Office Action Summary	Application No. 10/573,099	Applicant(s) LIU, LAISHENG	
	Examiner DAVID EASTWOOD	Art Unit 3731

DETAILED ACTION

2. Claims 1-3 and 5-6 are rejected under 35 U.S.C. 102(b) as being anticipated by Yiu (US 5976157).

Fig. 3

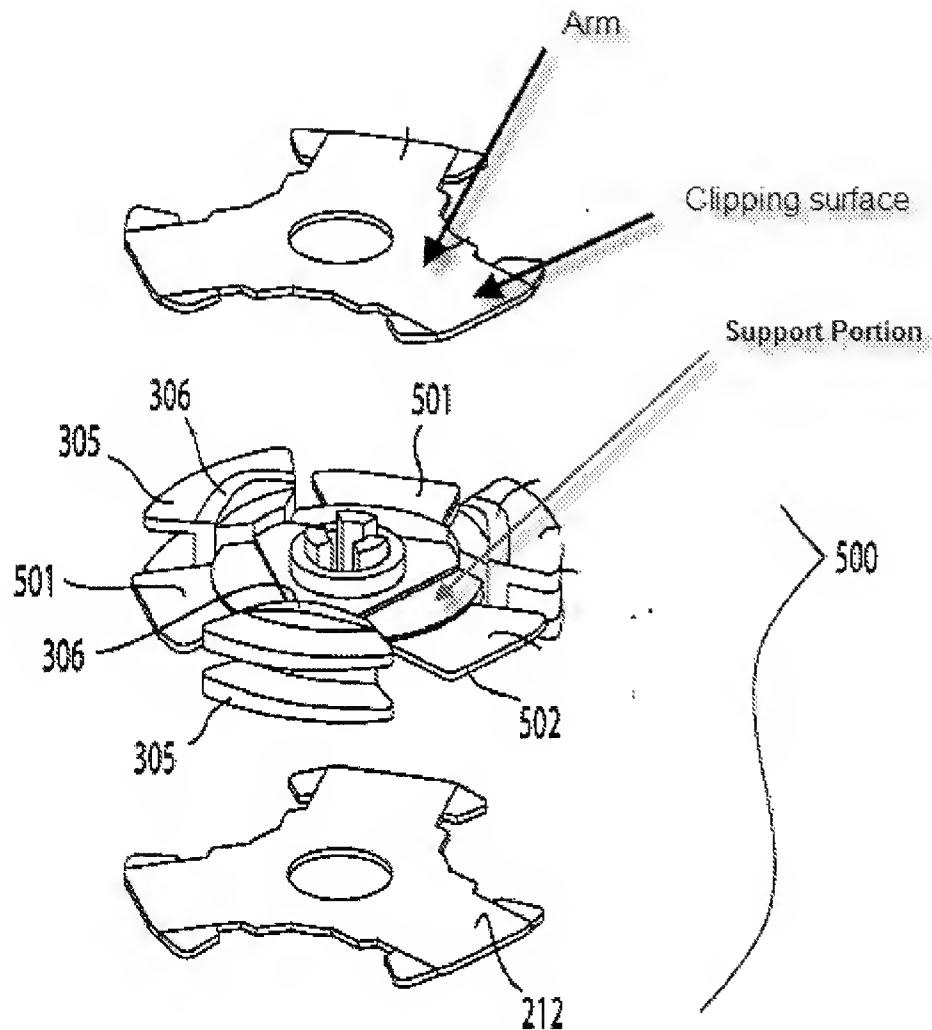
Regarding Claims 1-3 and 5-6, Yiu discloses an electrical depilator, comprising substantially a main body (11) a motor (216), a reduction gear set (204), an arcuate

shaft (214) and a set of single-pieces (500), said arcuate shaft being supported on a shaft seat (201) of the main body (11), a first stage gear of said reduction gear set being meshed with a driving wheel of said motor (203,204), a last stage gear being fixed on the single-piece which is located at the endmost position (208), each single-piece having at least one arm (portion of clipping surface 212 which connects to the through bore in the center of the single piece component see figure below), each arm having a clipping surface (212) and a supporting portion (see figure below.) provided at a surface of the arm opposite to the clipping surface (212).

Applicant alleges that Yiu fails to disclose the clipping surface and the support portion are formed on the same arm of the single-piece and are opposite to each other. The examiner respectfully disagrees. Once assembled the single piece 500 has a support structure (see figure above) formed (once assembled) to an arm of the clipping structure (212) (see figure 3 and above).

Applicant goes on to argue that Yiu fails to disclose each single-piece having at least one arm, each of the arms having a clipping surface and a supporting portion provided at a surface of the arm opposite to the clipping surface, the whole set of single-pieces being arranged in such a manner that the clipping surfaces are directly opposite to each other, a clipping gap being formed between opposite surfaces of the arms of two single-pieces. The Examiner respectfully disagrees. Yiu does disclose each single-piece having at least one arm (see figure above), each of the arms having a clipping

surface and a supporting portion provided at a surface of the arm opposite to the clipping surface (see figure above and the aforementioned argument), the whole set of single-pieces being arranged in such a manner that the clipping surfaces are directly opposite to each other (see aforementioned argument), a clipping gap being formed between opposite surfaces of the arms of two single-pieces (see aforementioned argument).
